MEMORANDUM

To: The Design Advisory Board
From: Mary O'Neil, AICP, Principal Planner
RE: ZP-23-15
Address: 176 South Winooski Avenue (VFW)
Date: February 28, 2023

MEMORANDUM

To: Design Advisory Board
From: Scott Gustin & Garret King
Re: 15 Conger Avenue
Date: February 28, 2023

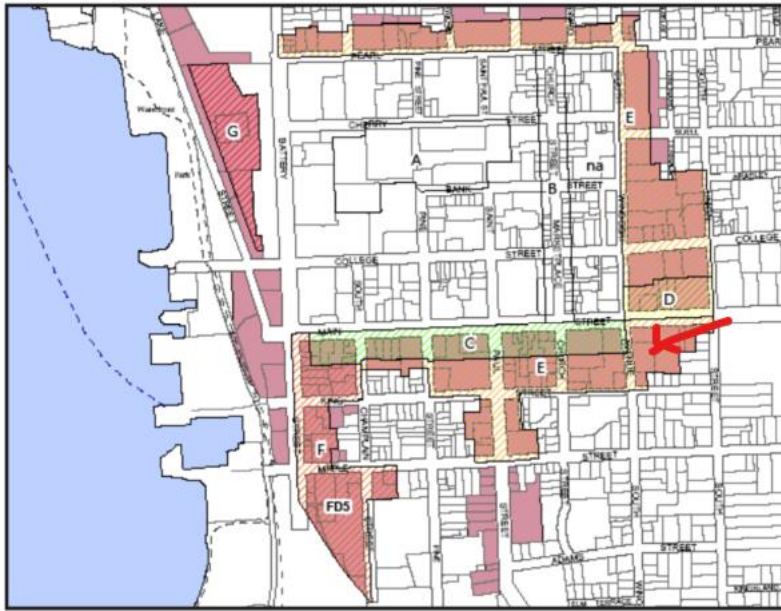
The by-right height is 4 stories or 45 feet. The applicant is requesting additional height subject to DRB review per Section 14.6.4 (f) for a total height of 55' feet.

The subject parcel is within Special Height Area E on Map 2 – *Specific Height Areas*. The proposed building height is 55' (62' inclusive of screening) within the DRB discretionary allowance. The application seeks 5 stories.)

A2-2.1

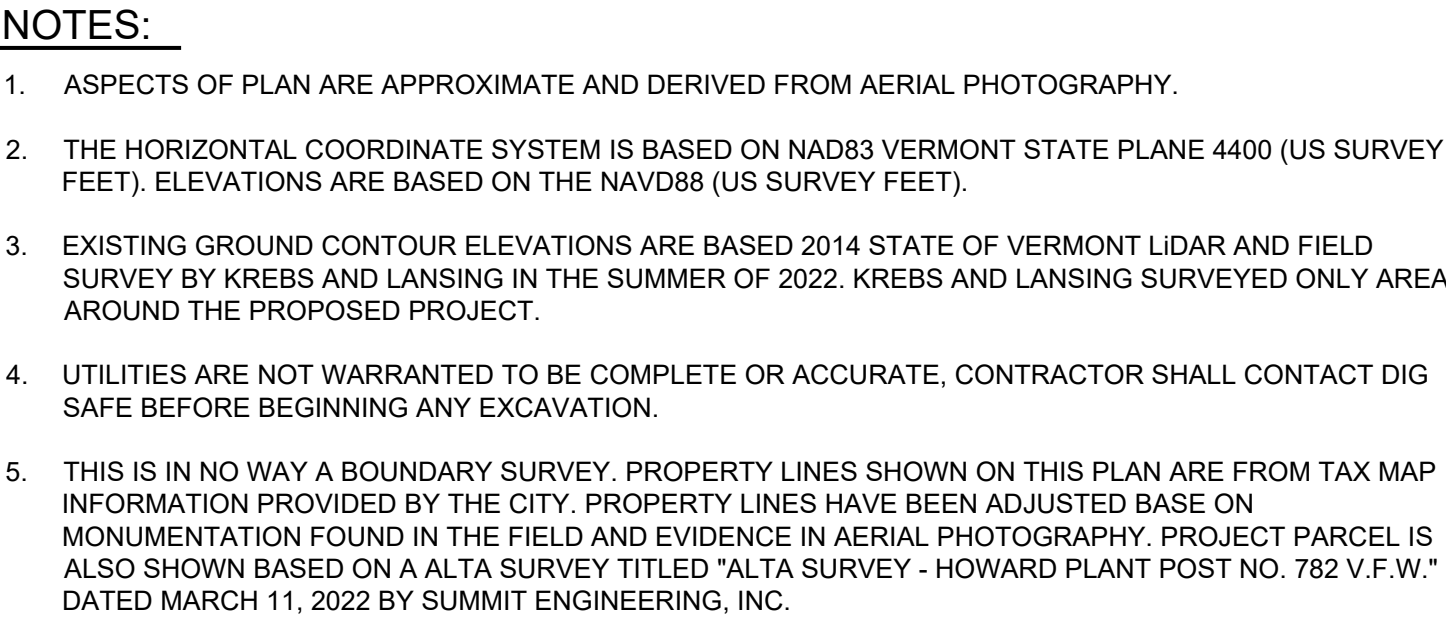
The corner and body of the building are divided by five-story vertical slots draped with Vermont slate shingles that taper slightly back at the top to reduce scale, separate volumes, modulate the roof line, increase sky view, and reference the many slate roof structures living the streets of Burlington. Each slate slot relates to the vertical circulation elements, the stairs and elevator.

The corner is a four-story volume clad in rich clay terracotta panels in a running bond pattern, a nod to the nearby downtown core. The body is the primary façade material and is made up of fiber cement panels narrow and tall installed in a vertical orientation around 3 story window bays. The bays themselves are outlined with deep trim and accented with terracotta panels.

The cap, or top floor, returns to the same rich dark color as the building base to create the illusion of recession. The southwest corner steps back from the primary façade at the roof terrace, a transition to the smaller scale neighborhood and sloping street grade.

DESCRIPTION:	Site Plan with Existing Structure		SCALE:	DATE:	Conger Ave.	Page: 3
			1/8"=1' at 11x17

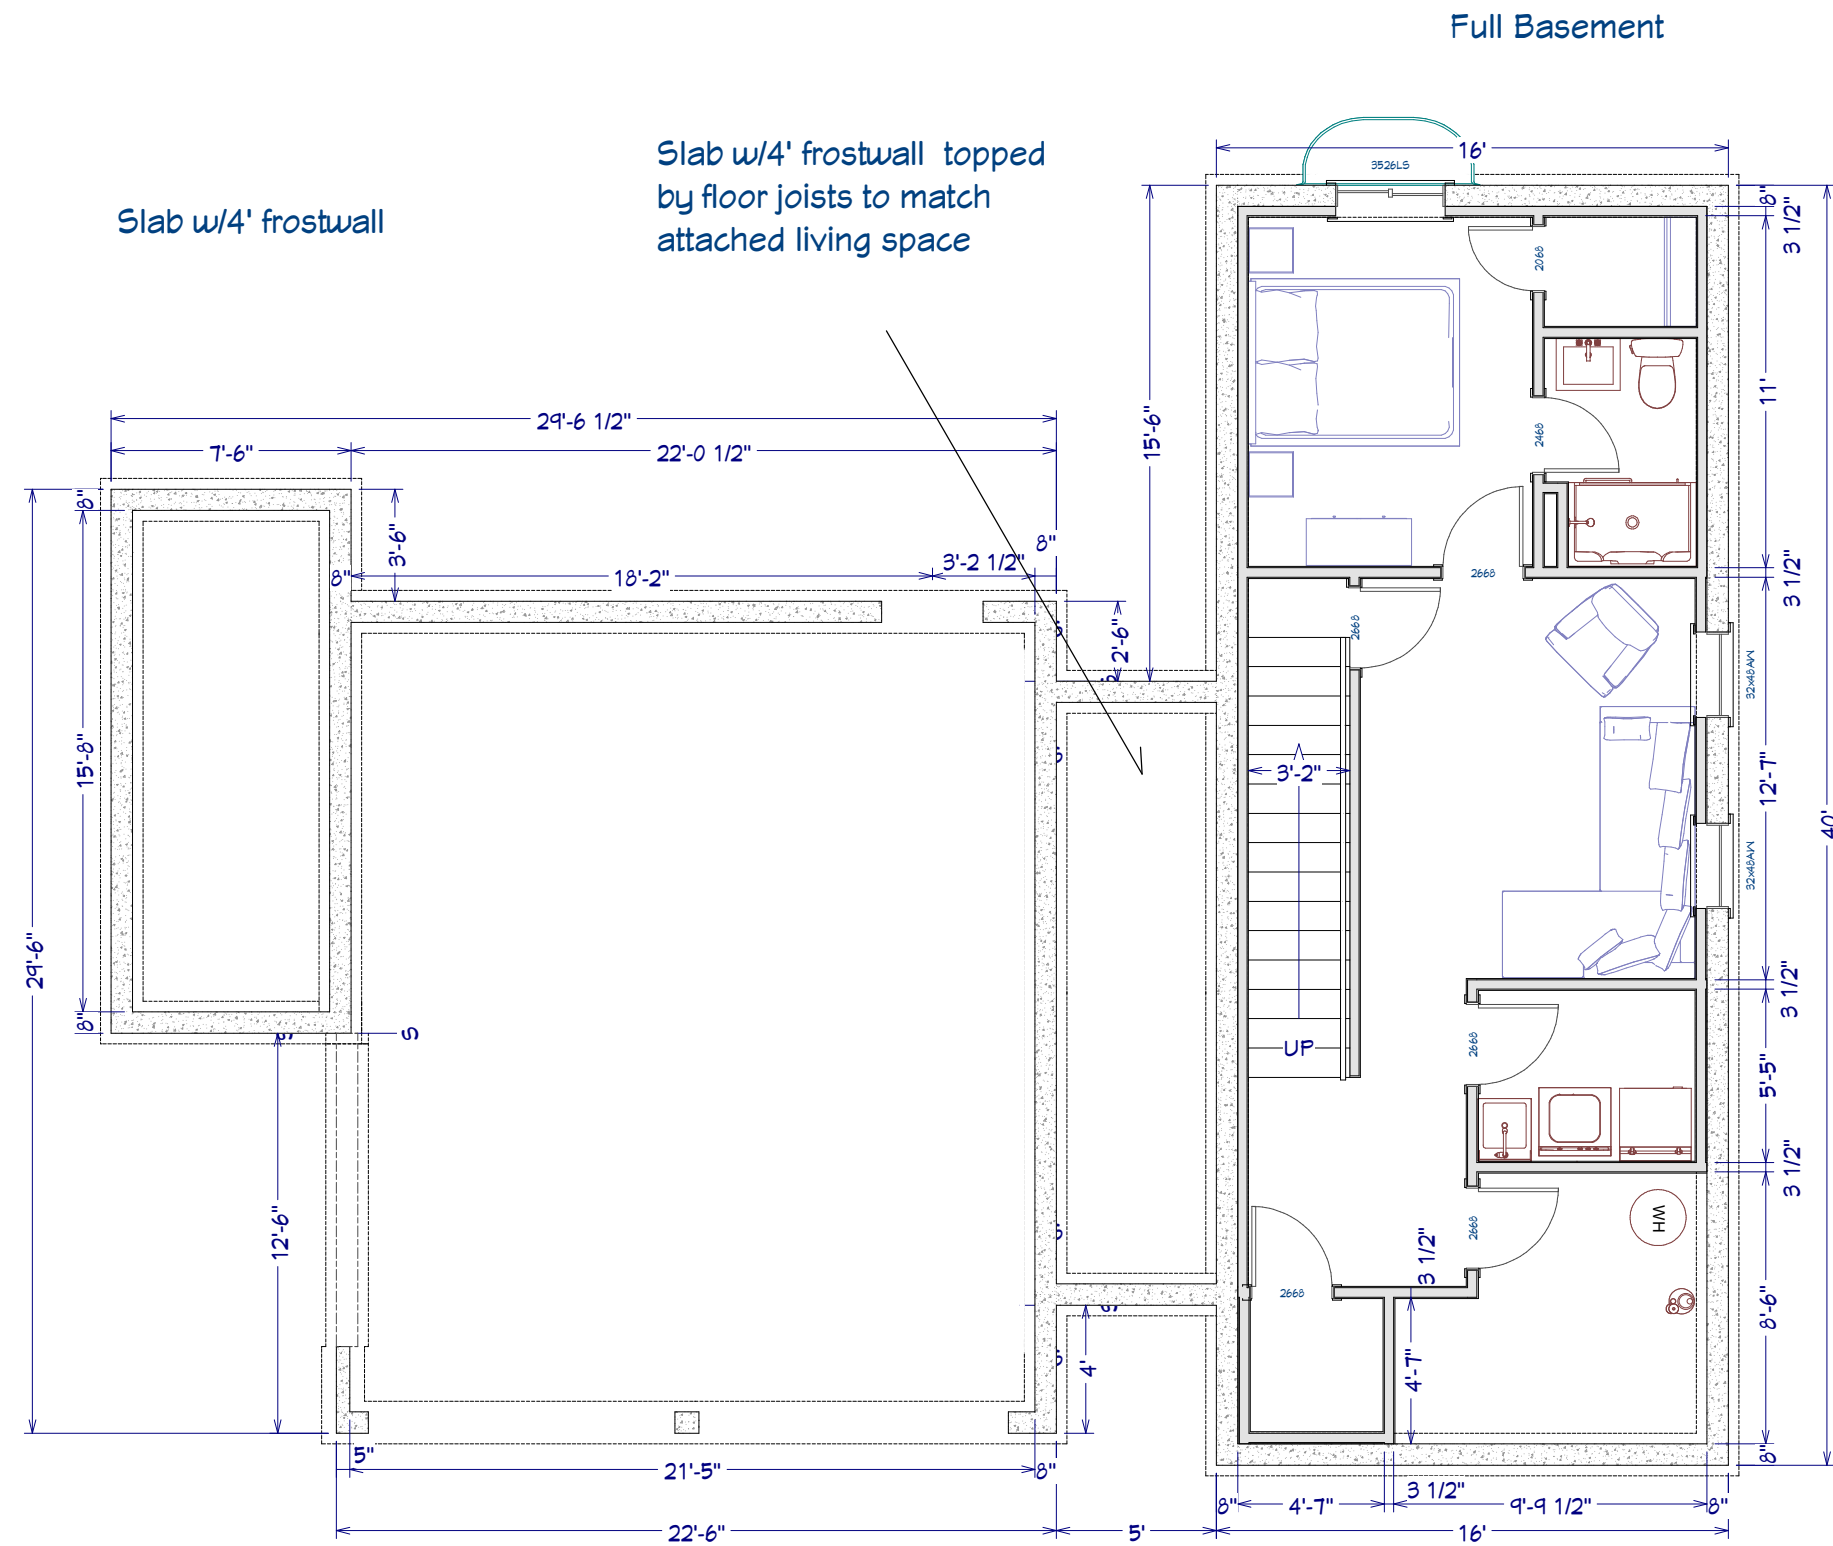
The new home will face Conger Avenue with a clearly identifiable front door and walkway. The new building will be shifted closer to the street than the existing garage. The prior zoning permit for this property (20-0166CA/VR) noted an existing front setback of 11' and a proposed setback of 5'. The 5' front yard setback was found to be acceptable based on an asserted front yard setback average of 7.5' for neighboring homes. The boundary survey expressly notes the front yard setbacks for neighboring homes. The actual average comes to 15'. The front yard setback of the proposed home can be +/- 5' of the average (i.e. as close as 10' or as far as 20'). The proposed home must be set back at least 10' from the front property line. In doing so, the rear yard setback cannot be less than the existing 12'. To avoid problems with increased nonconformity within the rear yard setback, the rear yard setback should be increased to at least lessen the degree of nonconformity as the prior application did. Note also that the proposed 3' northern side yard setback is acceptable. The southern side yard setback should be increased slightly from the proposed 5' 1" to at least 5' 8" for the 58' wide lot.

As part of the previous zoning permit approval for a home here, the Board determined that an open-air carport does not need to comply with the 25' front yard setback required for street-facing garages. This new project continues to include an open-air carport, albeit with living space above now. The entire width of the proposed residence is ~51'. The carport is less than 50% of that entire width at ~23' (and less than the upper limit of 24' width).

1. The proposed home must be set back at least 10' from the front property line. In doing so, the rear yard setback cannot be less than the existing 12.' To avoid problems with increased nonconformity within the rear yard setback, the rear yard setback should be increased to at least lessen the degree of nonconformity as the prior application did. The southern side yard setback should be increased slightly from the proposed 5' 1" to at least 5' 8" for the 58' wide lot.
2. The applicant is advised to work with the Department of Public Works to bring the curb cut(s) into compliance with current standards and to restore the stretch of greenbelt in front of the subject property.

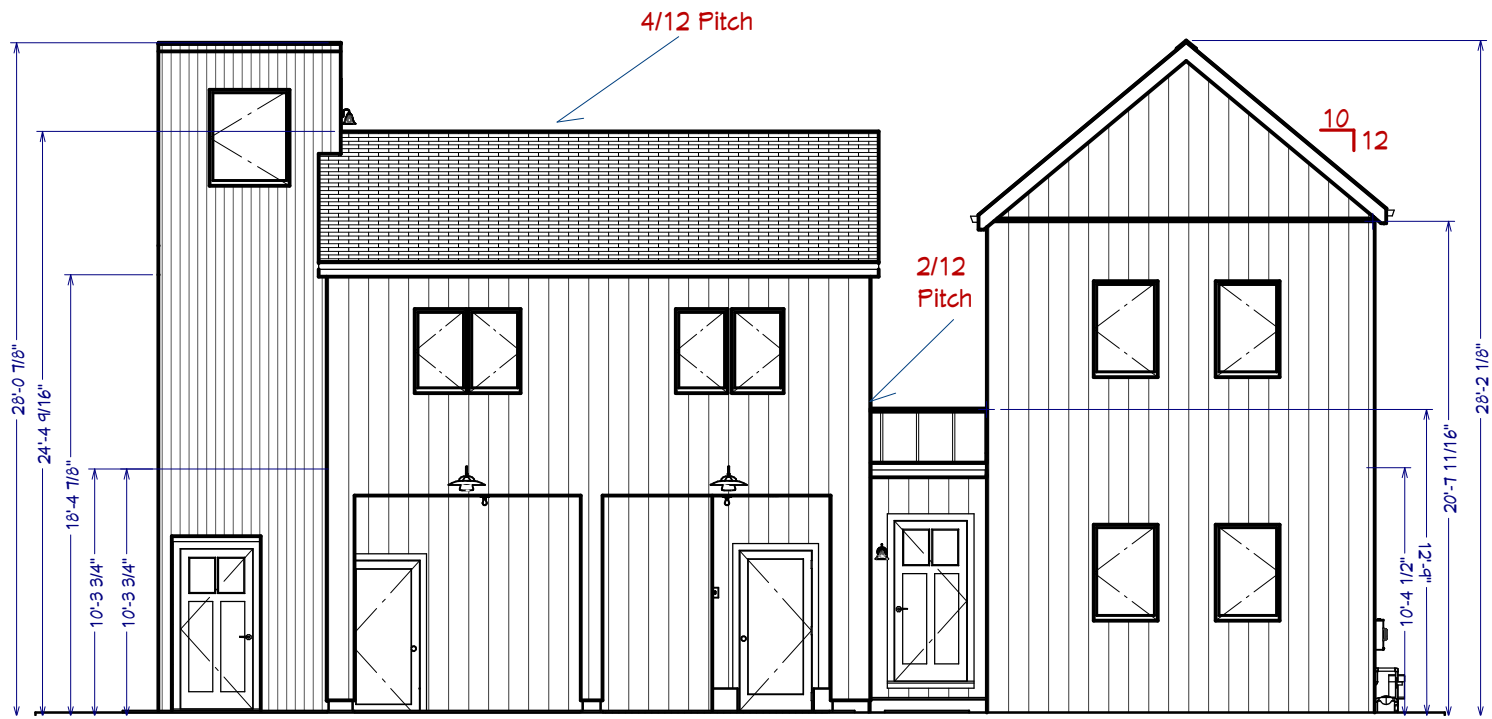
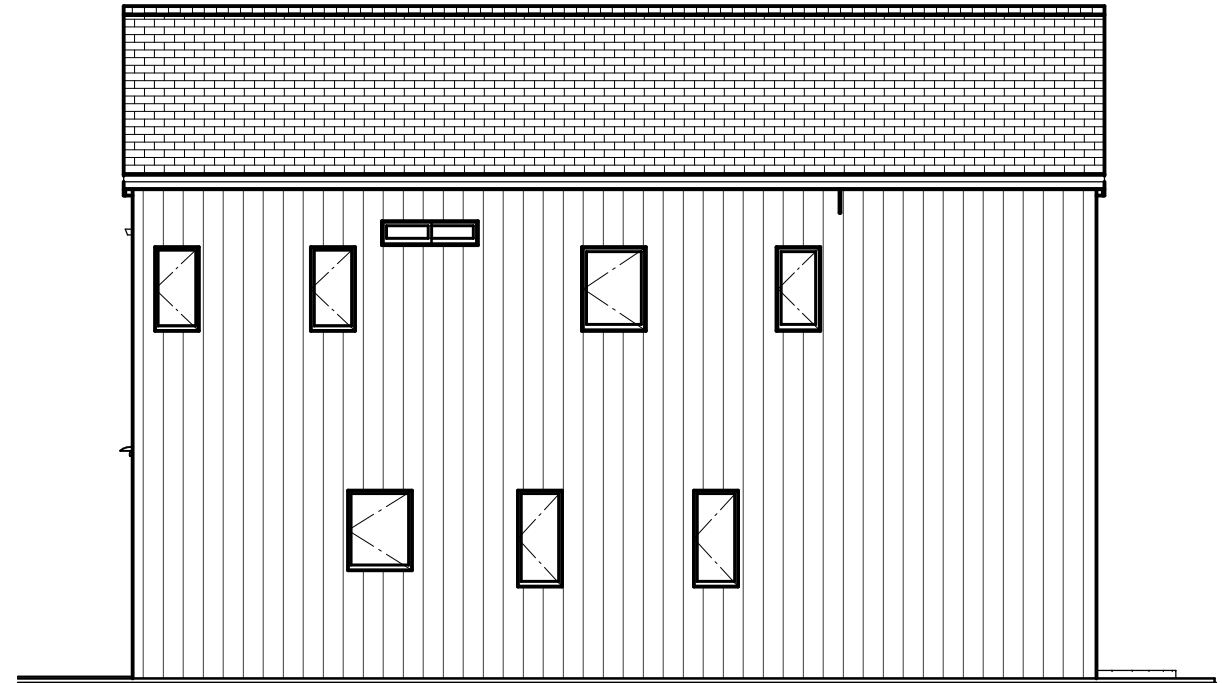
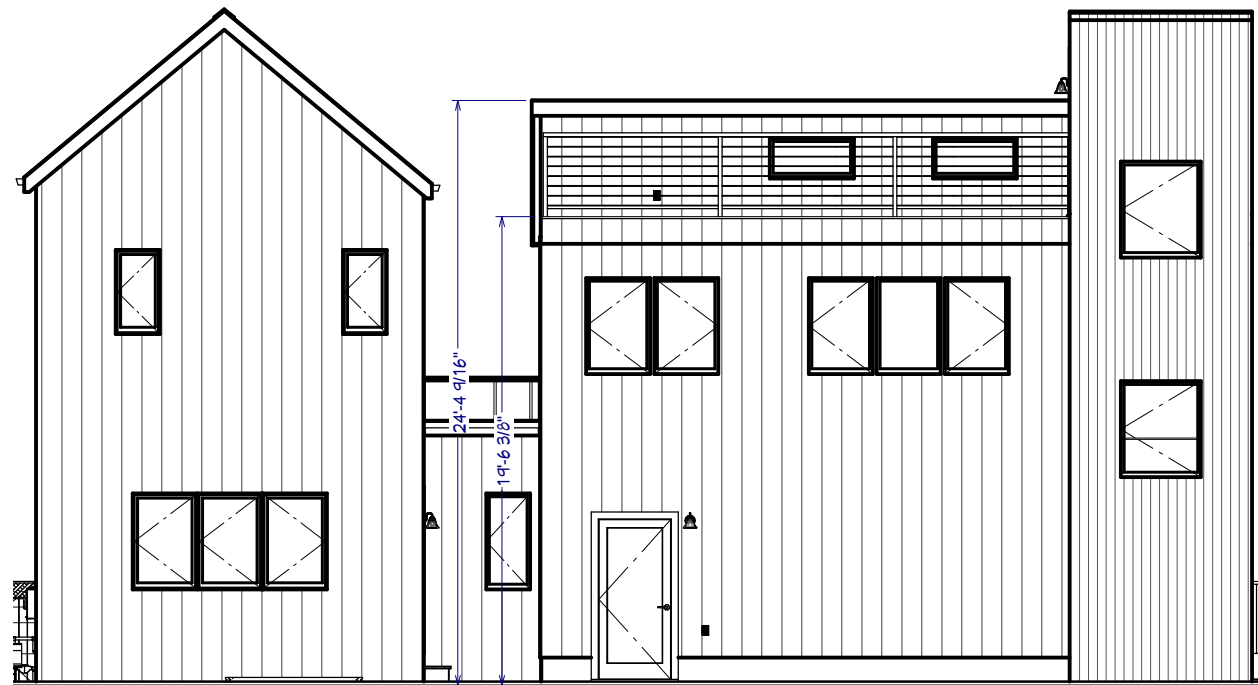
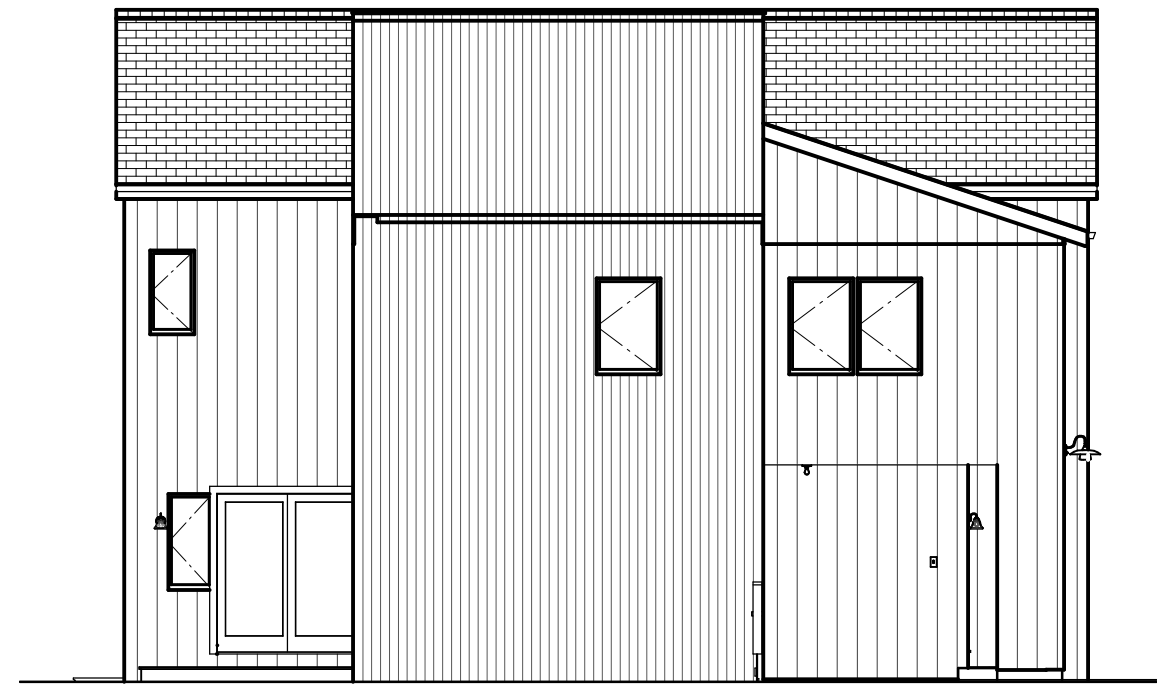
New outdoor lighting is included in this application. The elevation plans depict exterior fixture locations, and fixture specification sheets have been provided. All of the fixtures are shielded (although not necessarily cutoff) and will illuminate building entries. As all of the fixtures utilize low output lamps, full cutoff fixtures are not required.

The home is similar scale and height with other homes in the neighborhood. The massing of the structure is broken up into distinct components that create variation in height as well as setback that reduce the apparent building mass. Positioning of the carport and roofs also add

Rooflines vary with the individual building components. They are a mix of gable and shed roof styles and fit within the residential context of this neighborhood.

Landscaping Plan

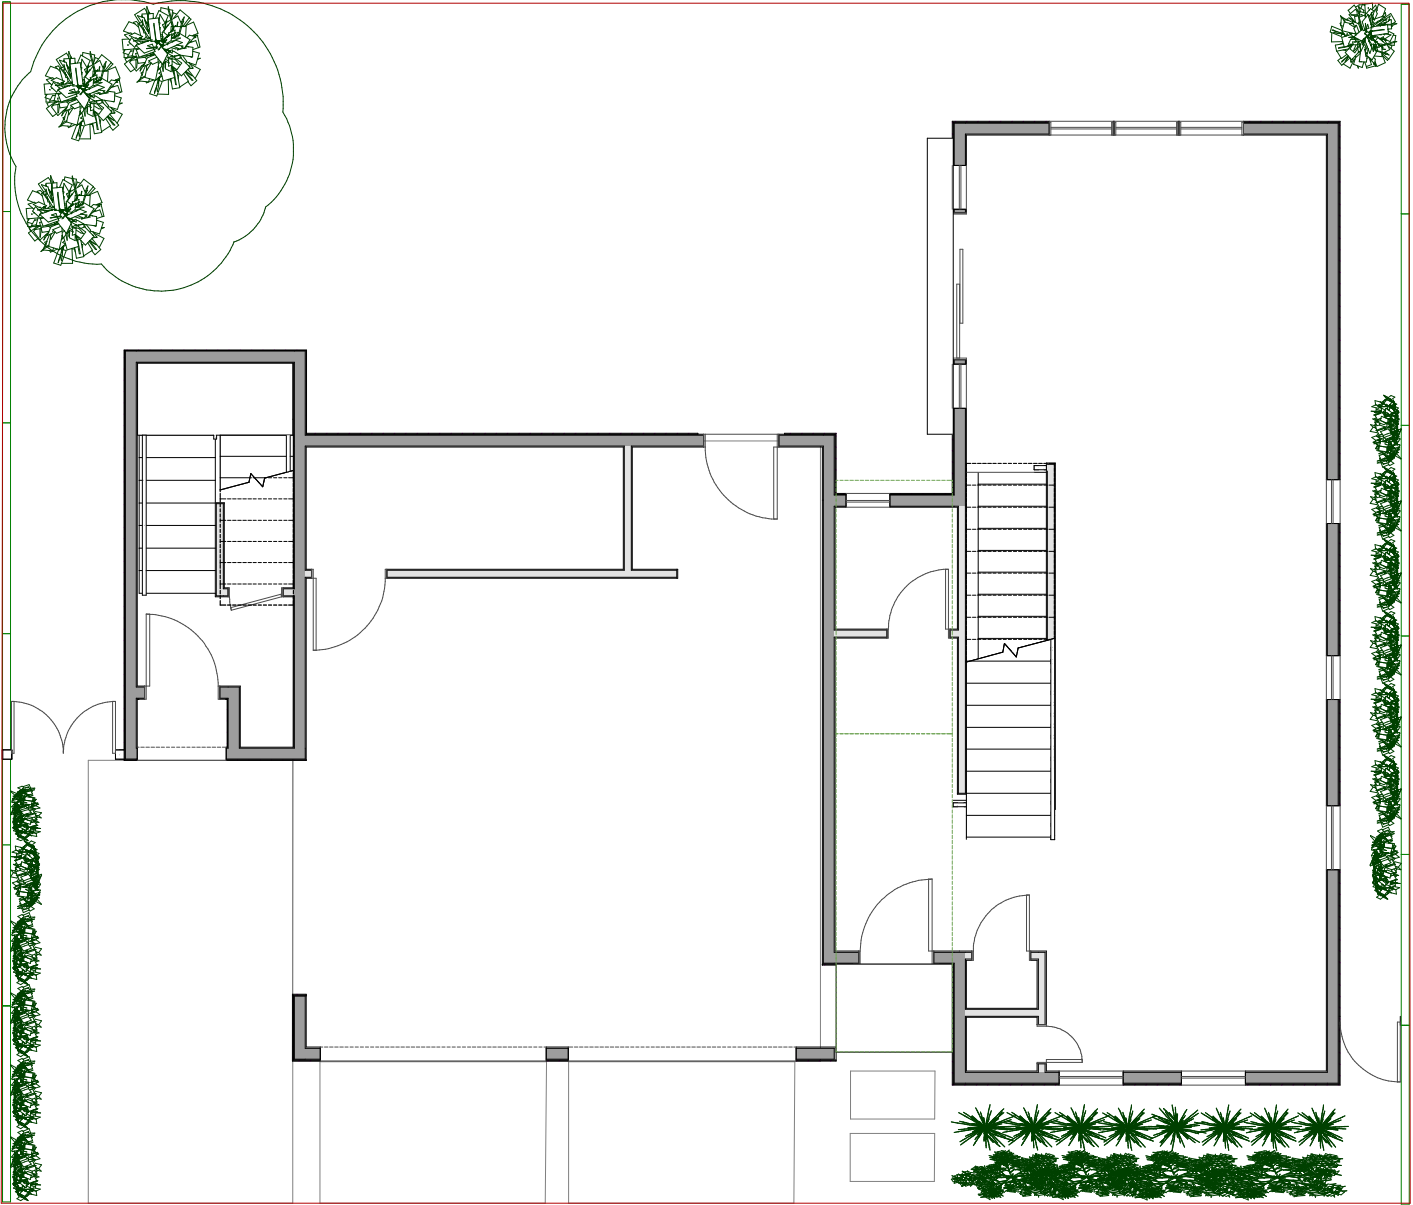
A full plan of the property has a landscaping plan noting that a fence will be constructed around the property as well as what plants will be installed. The proposed fence will be horizontal panel fencing made out of a dark stained wood that will be 5 feet tall (except within the driveway clear sight triangle). The fence will go around the entire side and rear perimeter of the property. The proposed shrubs, grasses, and ivy are not invasive species, and add color as well as natural aspects to the overall design elements on the property. Proposed trees in the rear yard will provide shade cover to add to the privacy of the rear outdoor space. On the front of the property the landscaping of grasses and shrubs as well as an inviting walkway to the front door creates an attractive appearance that adds to the overall design of the property.
